DM/25/1434|Proposed demolition of an existing dwelling house, stables and barn buildings and the proposed development of 27 dwellings, with a new vehicular access, associated landscaping, parking, open space, and all other associated development works. (Amended plans, FRA and Drainage Strategy and TA Addendums received 12/12/25) Land Rear Of Chesapeake Reeds Lane Sayers Common Hassocks West Sussex BN6 9JG

I would like to make the following additional comments concerning the documents provided by the applicant for the above application since my previous submission.

Diagram of all the existing and new parking areas along Reeds Lane and the accesses onto it

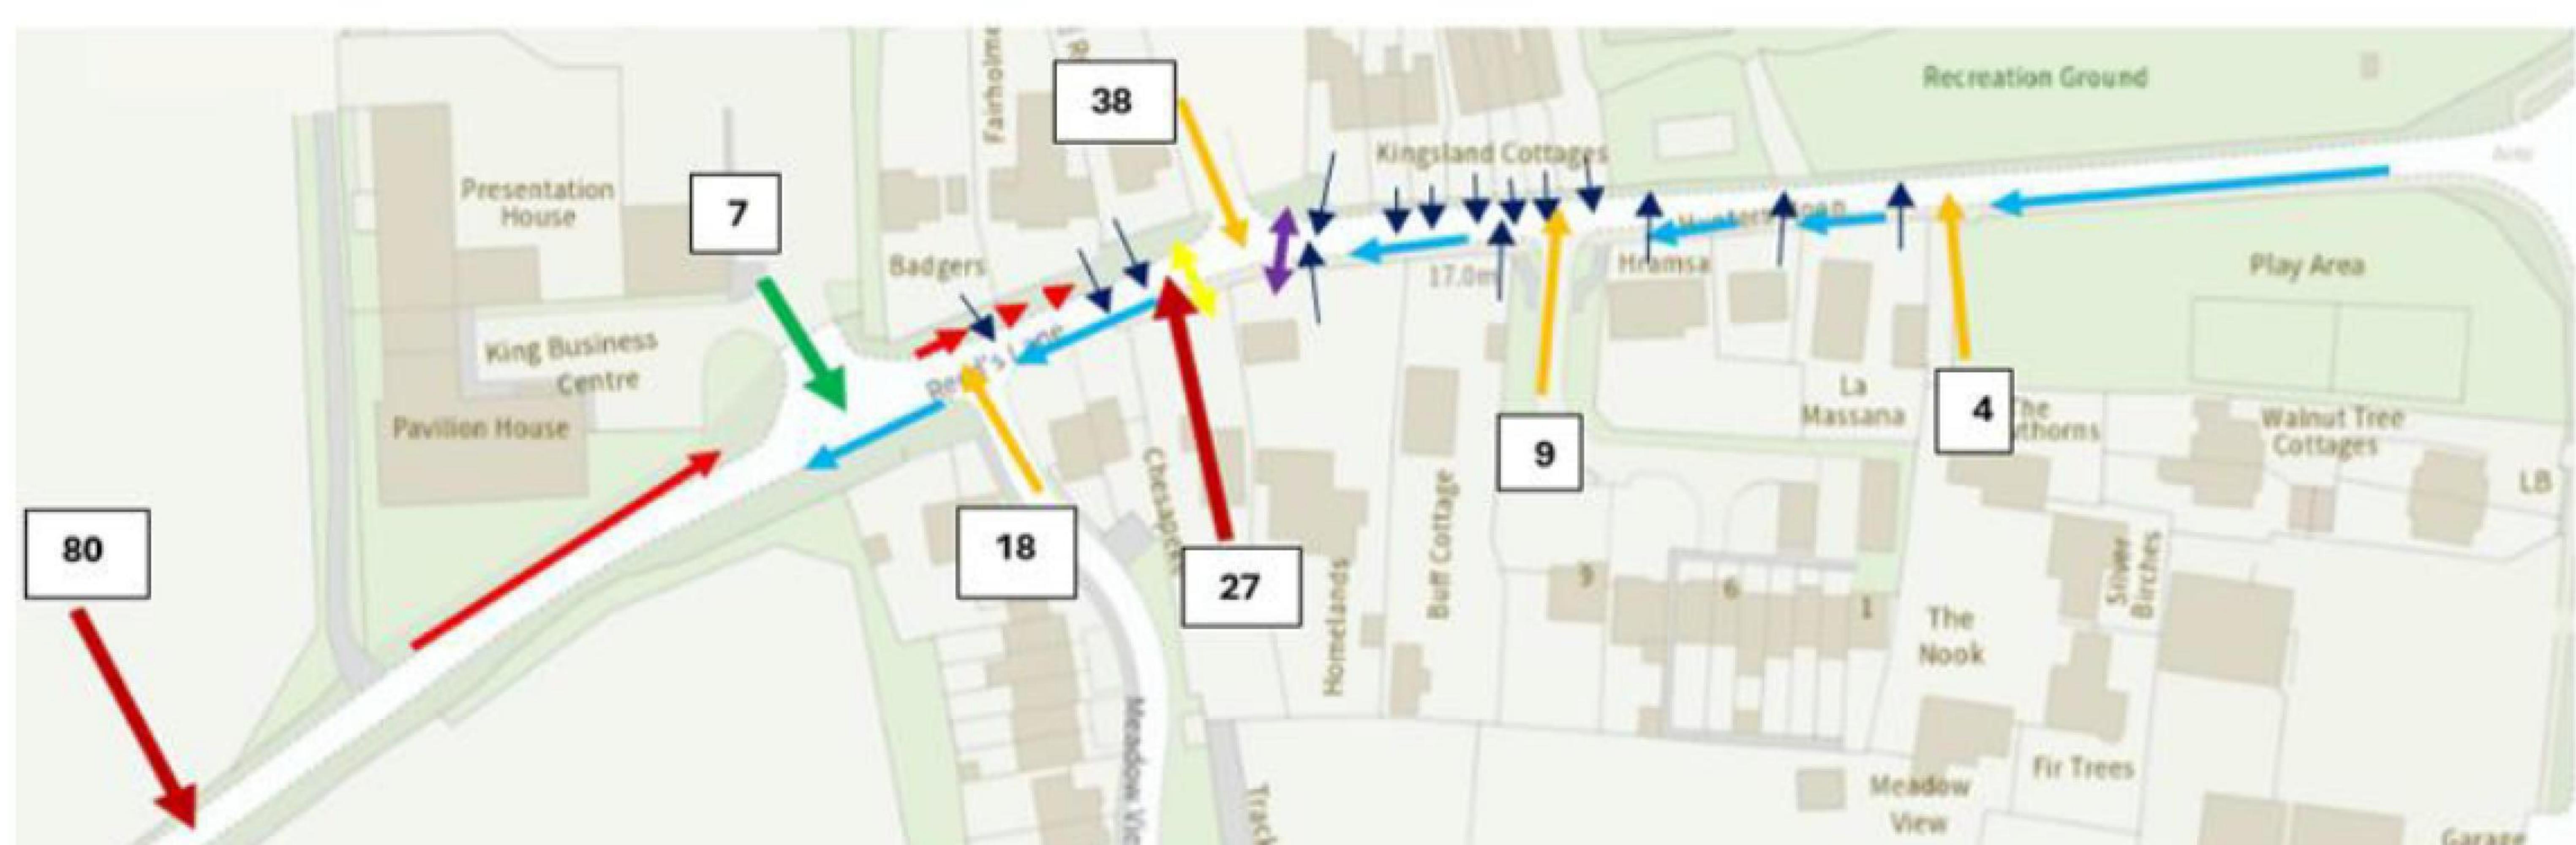
Vehicles park all along Reeds Lane, from the junction in the east with the London Road (B2118) to Kings Business Park in the west. Any length of pavement without any traffic restrictions painted along it is extremely attractive for parking vehicles against. These lengths appeal to the residents of the new housing estates, their visitors, and existing residents of Reeds Lane, Osborn Close and the Meadowview estate who lack enough parking on their premises for all of their vehicles. It would also appeal to those using the businesses of Kings Business Centre, such as the NHS customer facing Spa Medica Eye Clinic, and also to the houses and businesses in London Road who similarly lack parking capacity on their premises. Some parking restrictions have been applied at the eastern end of Reeds Lane but this has only resulted in the on street parking moving further westwards down the road.

On street parking not only causes traffic congestion but results in it being difficult for vehicles to see on coming traffic to then be able to stop in time before colliding with them, and reduces the road to the width of a single track. Vehicles (including vans, lorries, HGVs and Farm vehicles) frequently have to duck and dive between parked cars, pull into driveways and mount pavements to let traffic pass, or sometimes they even have to reverse back down the road. It is also very difficult for pedestrians to see around parked cars without having to first step into the road, in order to do so, when crossing it. This is equally an issue at the new Reeds Lane crossing by the Woodlands housing estate because of the curved nature of the road at this point. From experience it can be quite difficult and terrifying as a pedestrian to cross the road at this point.
